**TOPOGRAPHIC SURVEY  
SEASPECT SHORT PLAT  
JOHN KAHAN**

PERMIT DRAWINGS  
 DATE: 06.10.22  
 SHEET SIZE: D (24X36)  
 REVISIONS

PROJECT TITLE:  
**Clarkson Residence**  
8163 West Mercer Way  
Mercer Island, WA 98040

1 SITE SETBACK & BUILDING PAD PLAN  
1" = 10'-0"

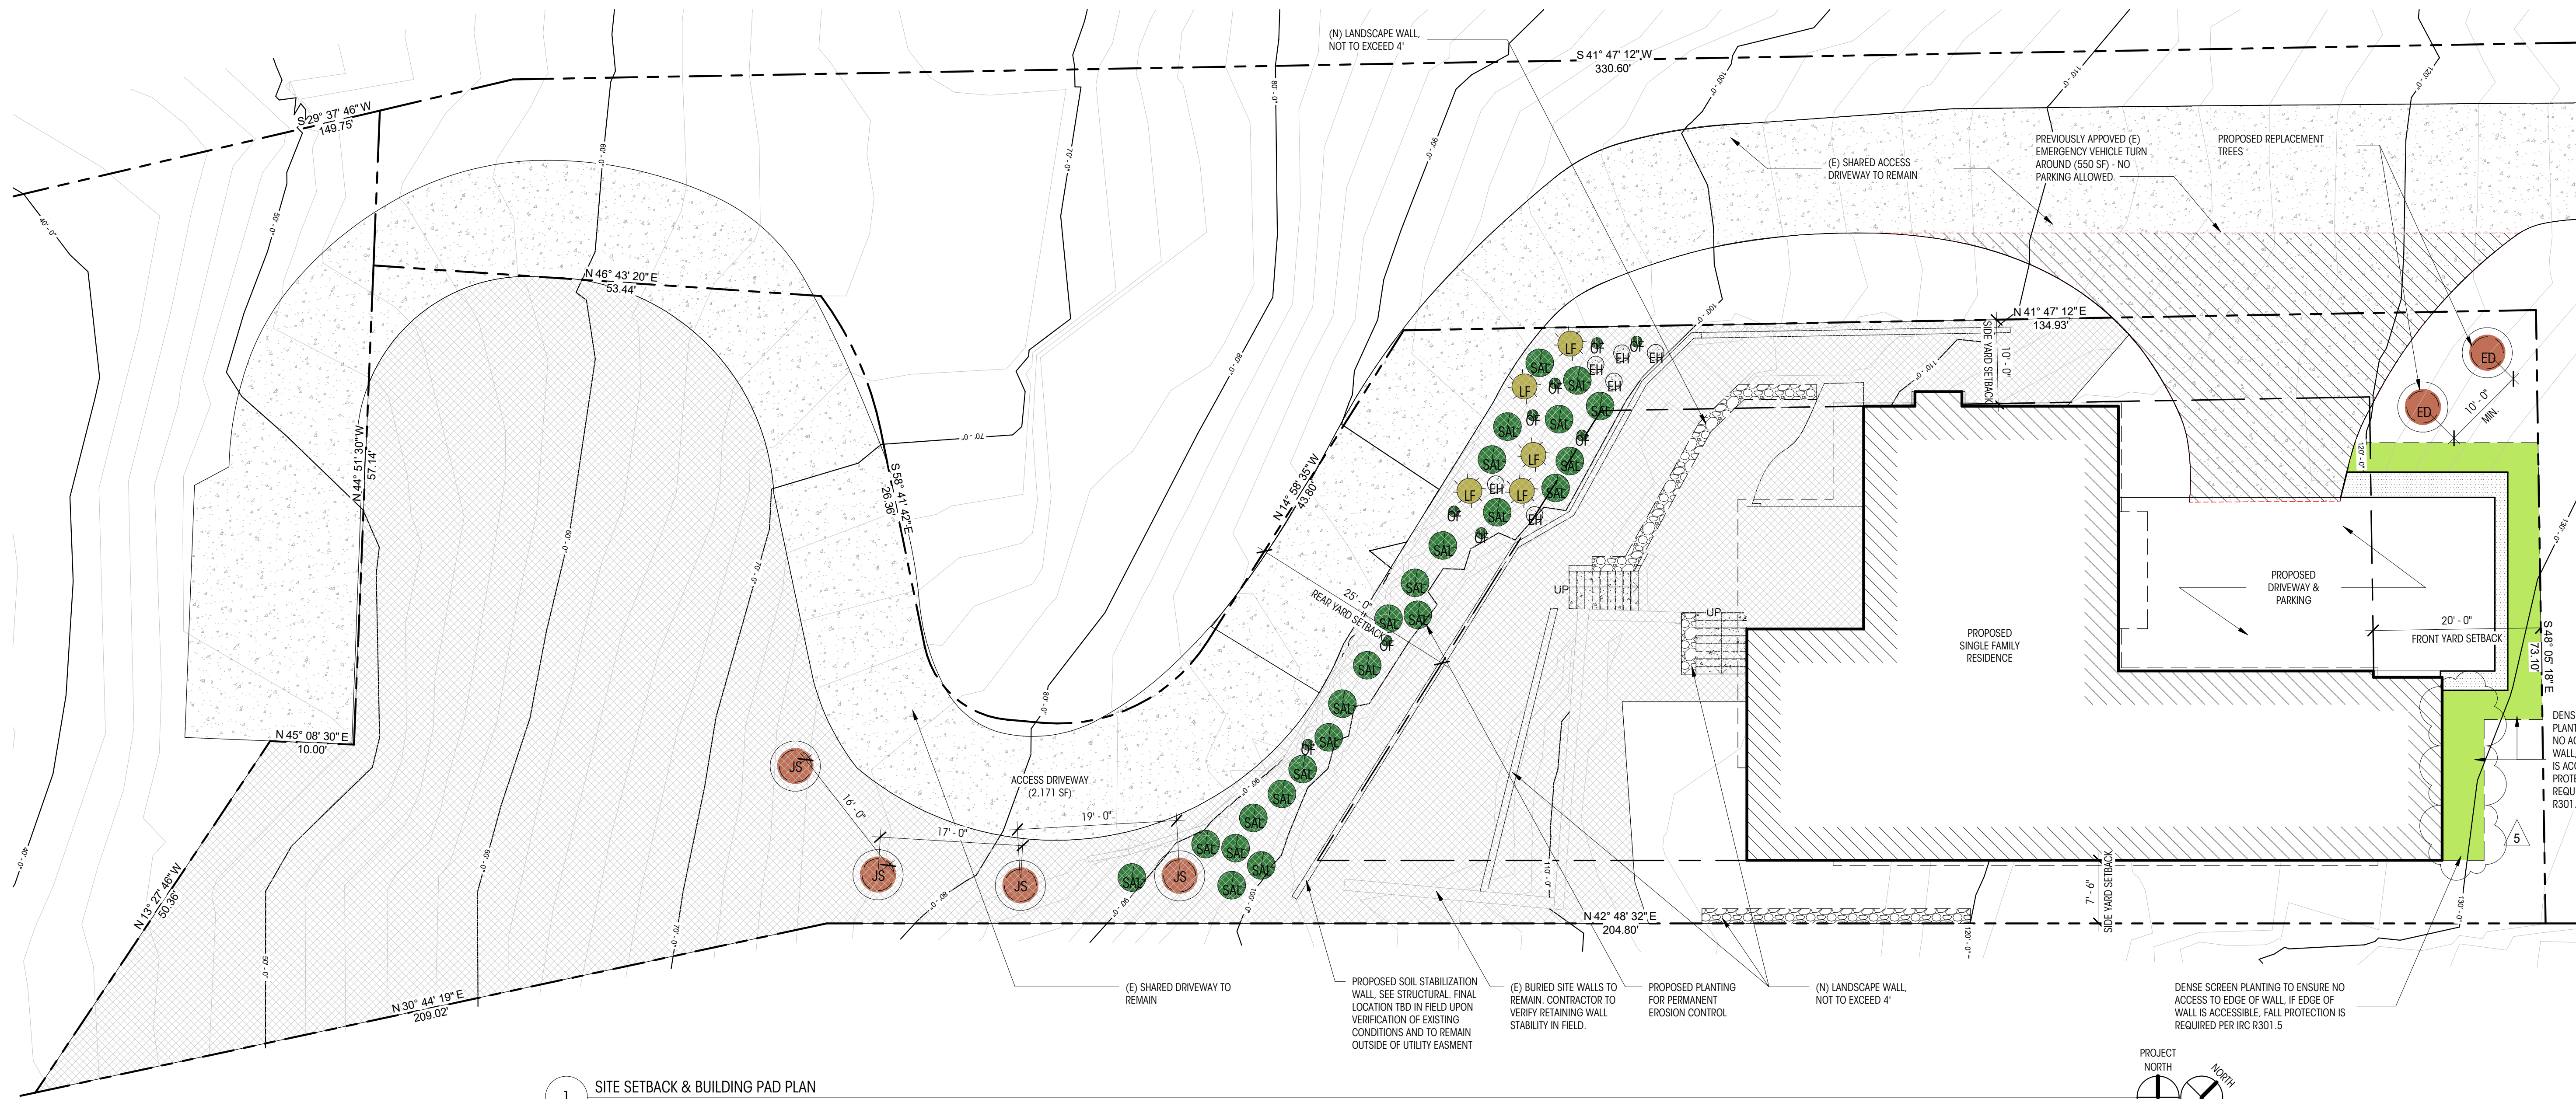
- REVISED LOCATION OF REPLACEMENT TREES
- SHIFT OF PARKING RETAINING WALLS TO NORTH AND SOUTH
- CHANGE IN SOIL RETENTION WALL: PREVIOUSLY AS PART OF THE FOUNDATION SYSTEM, NOW MOVED TO WESTERN YARD ADJACENT TO ROAD IN ORDER TO ALLOW FOR LANDSCAPE WORK
- REVISED FOUNDATION AS A RESULT OF SOIL STABILIZATION WALL LOCATION MOVE
- CHANGES TO HARDSCAPE CALCULATIONS AS A RESULT OF SOIL STABILIZATION WALL, PATIO EXTENSION AND SITE STAIRS
- GRAPHICS/PATTERNS/HATCHES HAVE BEEN COORDINATED FOR CONSISTENCY

PROPOSED LOWER LEVEL FLOOR PLAN  
1/4" = 1'-0"

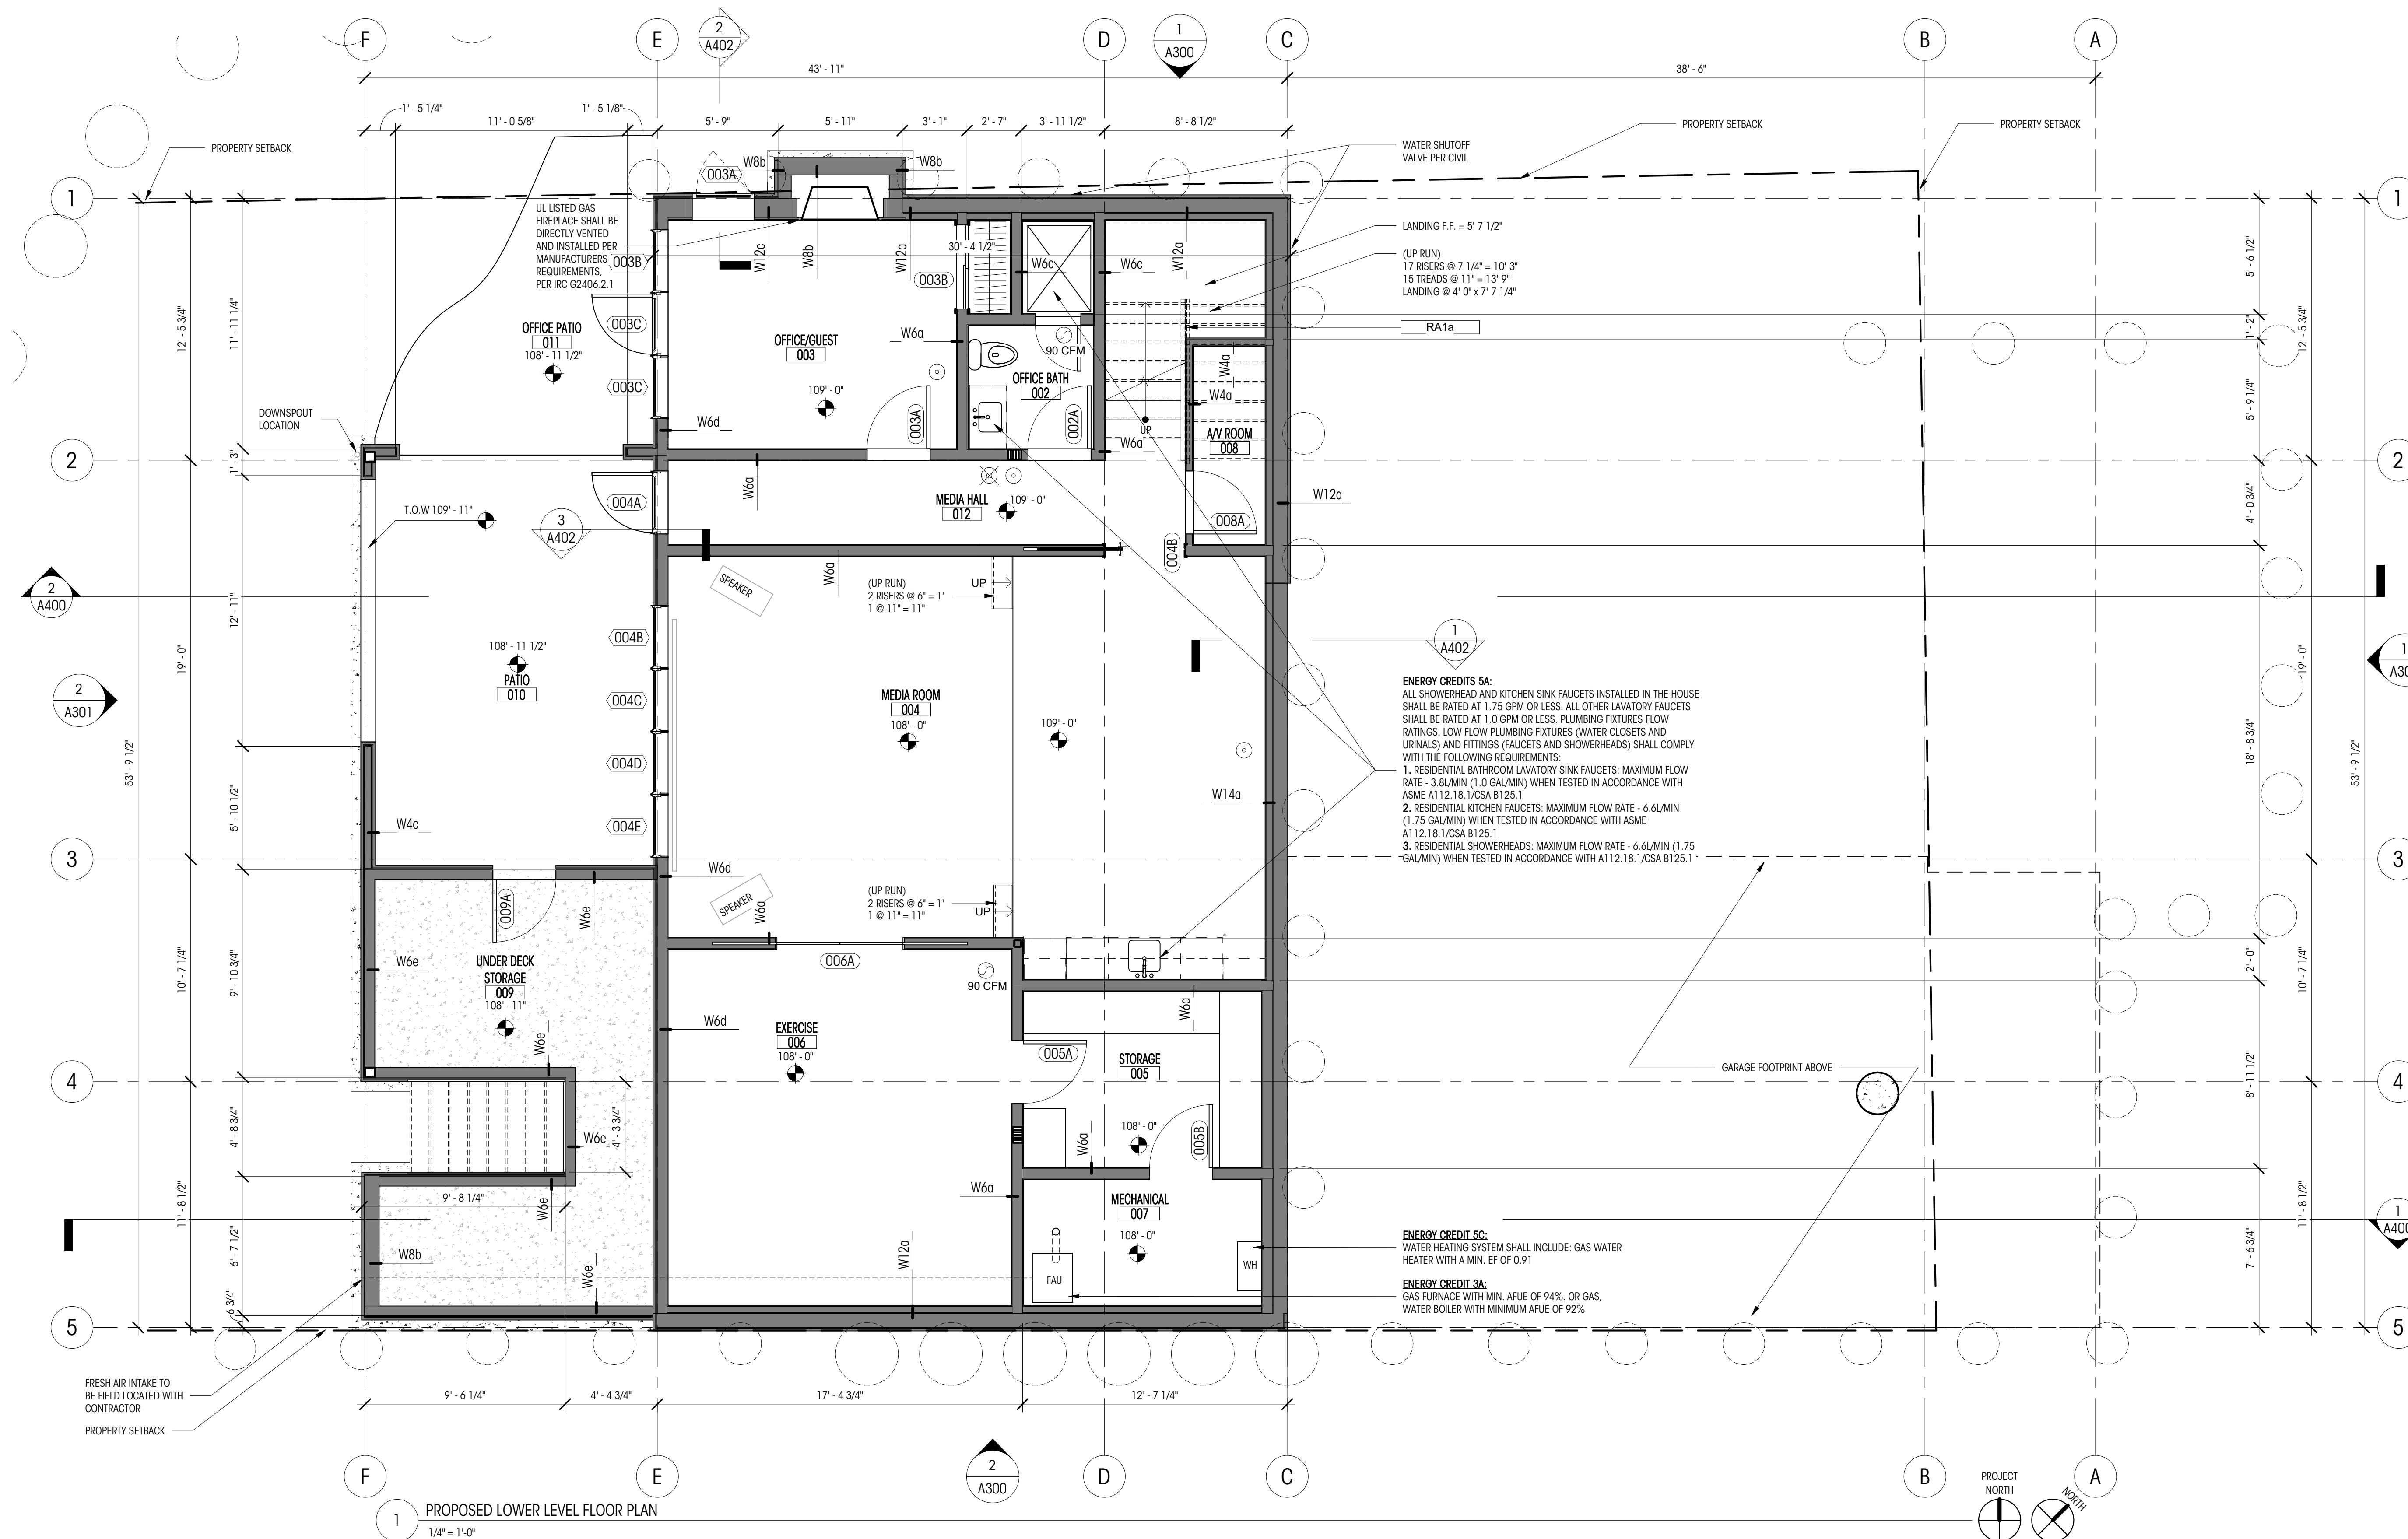
- NON-STRUCTURAL INTERIOR LAYOUT CHANGES TO BASEMENT LEVEL.
- ADDITION OF FIREPLACE AT BASEMENT LEVEL.
- ADDITION OF PATIO AT BASEMENT LEVEL.
- WINDOW SIZE & LOCATION CHANGES.
- EXTENDED WESTERN PATIO TO THE NORTH AND SOUTH
- LEVEL CHANGES: DRIVEWAY & GARAGE LEVEL DROP BY 12"; BASEMENT LEVEL DROP BY 12";
- CHANGE TO ABE AS A RESULT OF EXTENDED GARAGE AND EXTENDED COVERED DECK.
- CHANGES TO HARDSCAPE CALCULATIONS AS A RESULT OF SOIL STABILIZATION WALL, PATIO EXTENSION AND SITE STAIRS.
- GRID LINES HAVE BEEN UPDATED FOR CLEAR EFFICIENT DIMENSIONS.

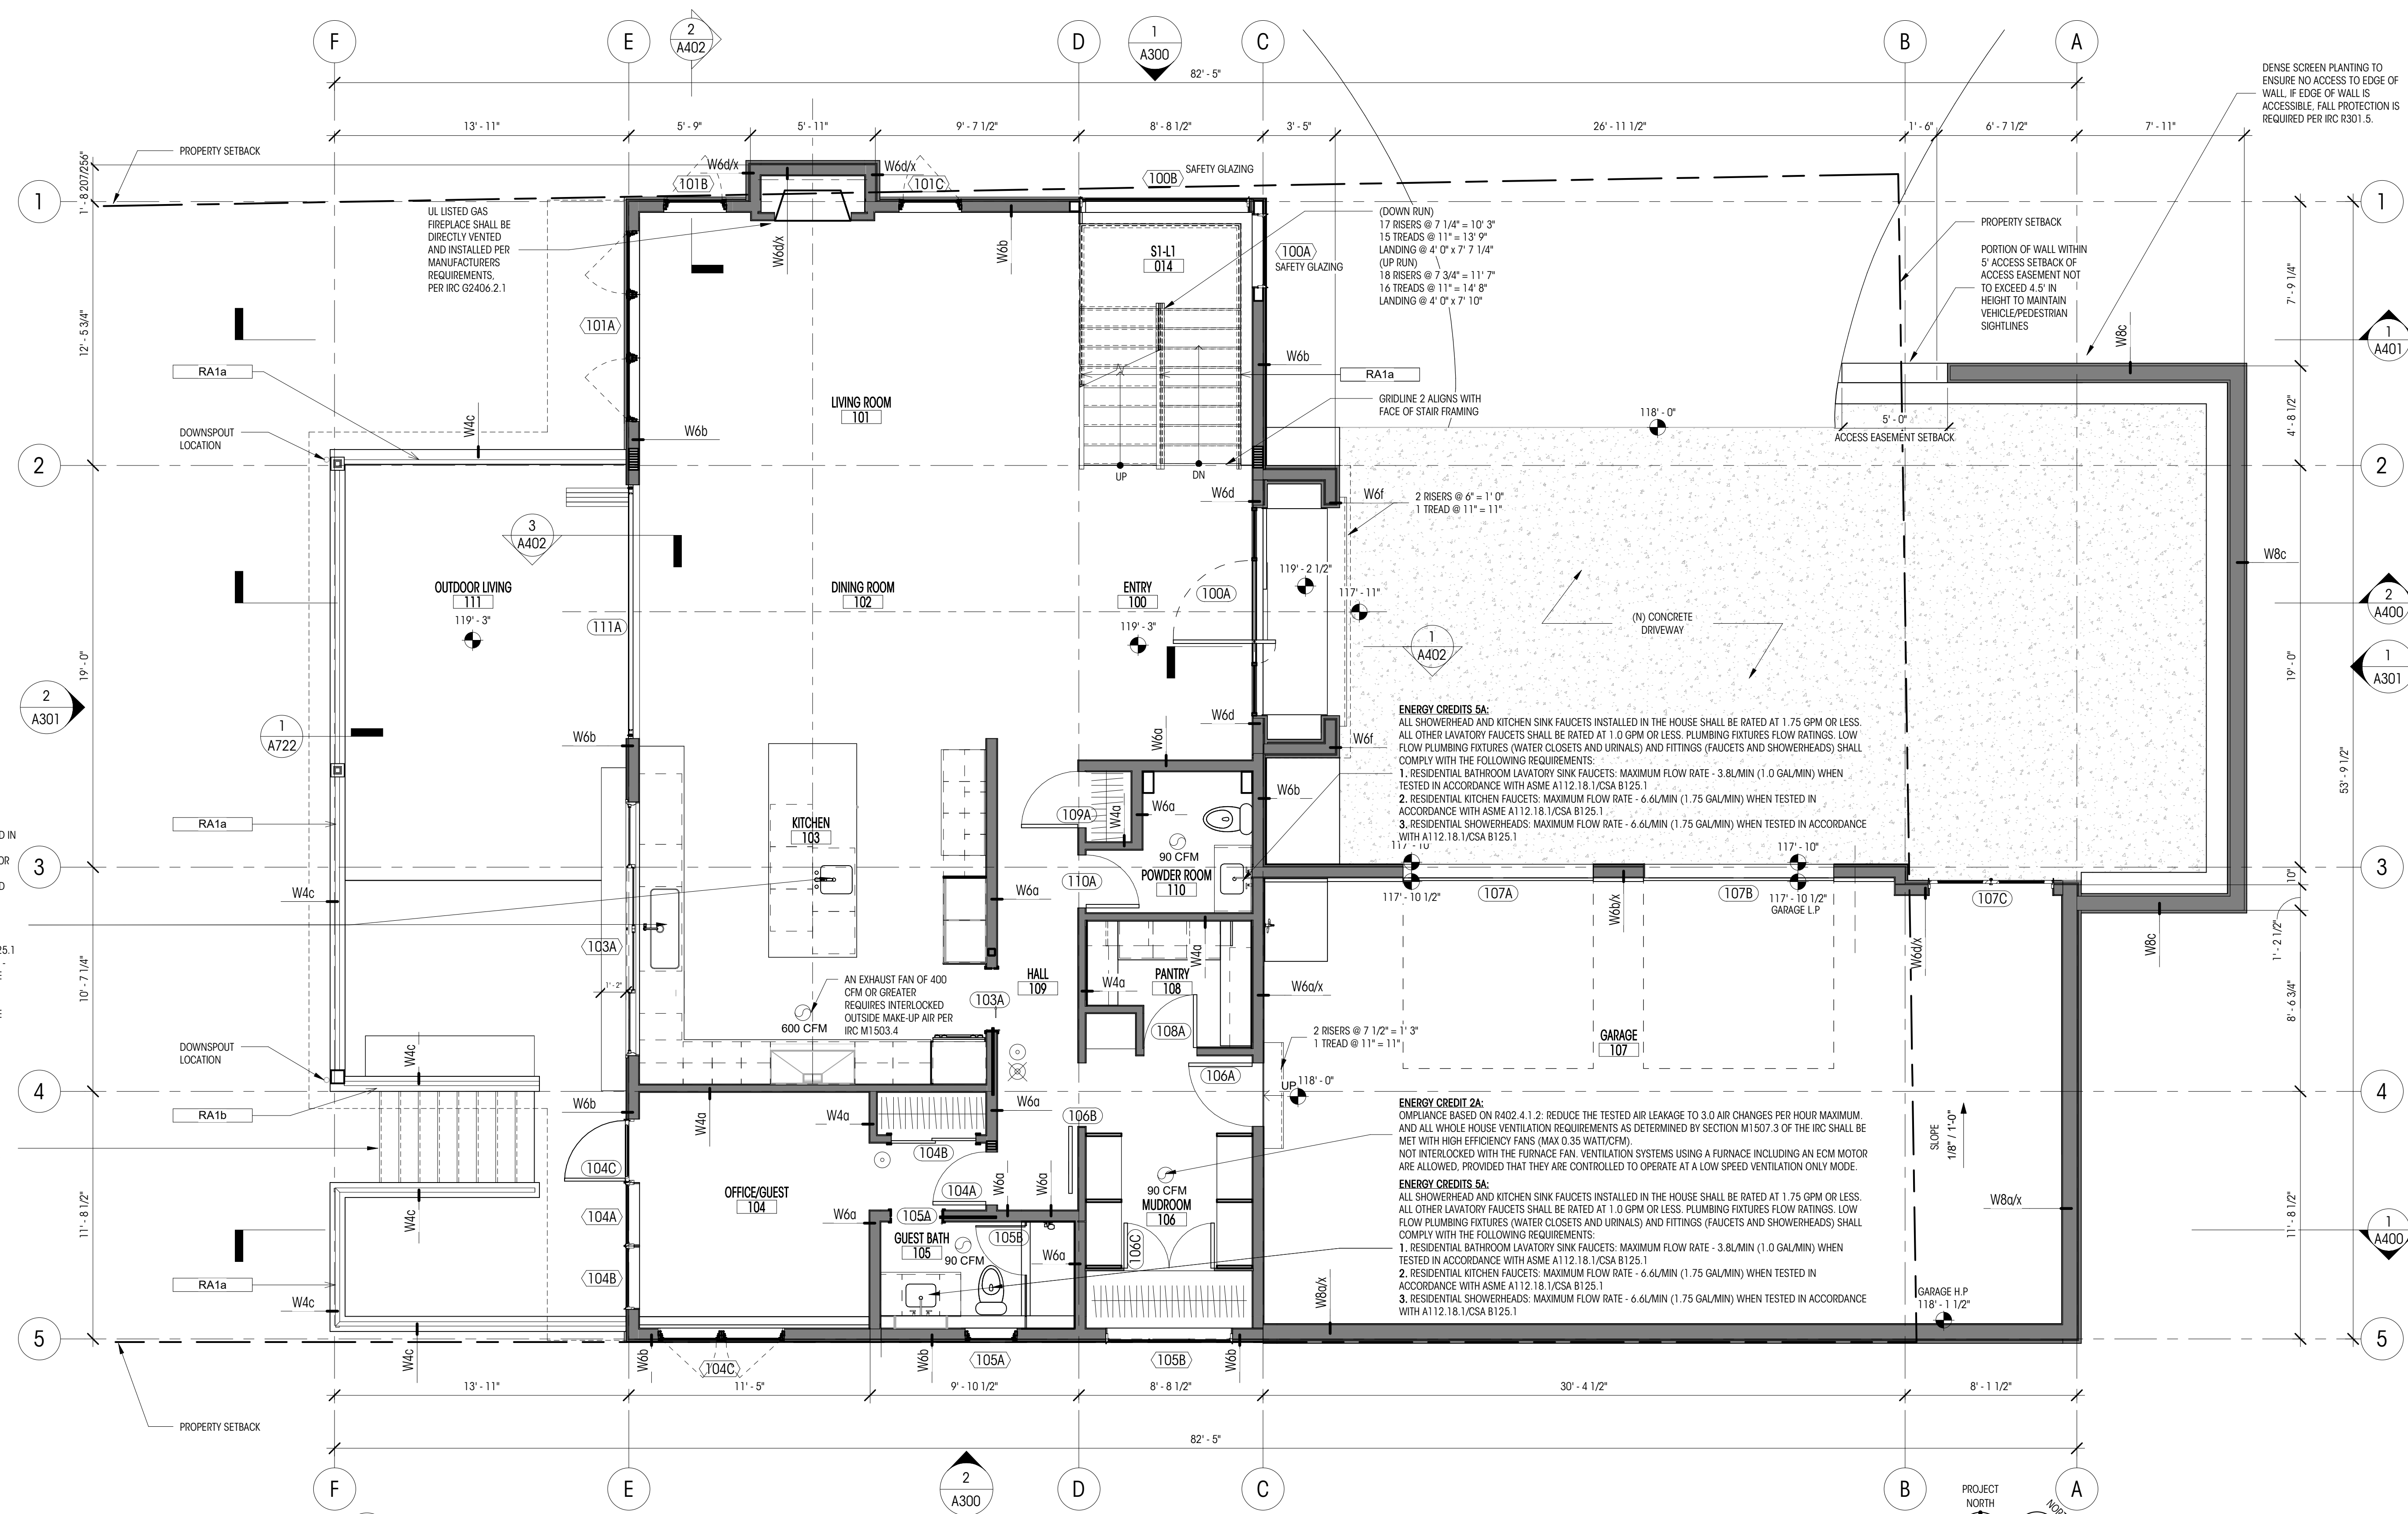
- INTERIOR LAYOUT CHANGES TO MAIN LEVEL
- ENTRY DESIGN CHANGE
- WINDOW SIZE & LOCATION CHANGES
- EXTENDED WESTERN PATIO TO THE NORTH AND SOUTH
- LEVEL CHANGES: DRIVEWAY & GARAGE LEVEL DROP BY 12"
- SHIFT OF PARKING RETAINING WALLS TO NORTH AND SOUTH
- EXTEND GARAGE EAST INTO FRONT YARD SETBACK AS ALLOWED BY CODE 19.02.040.D
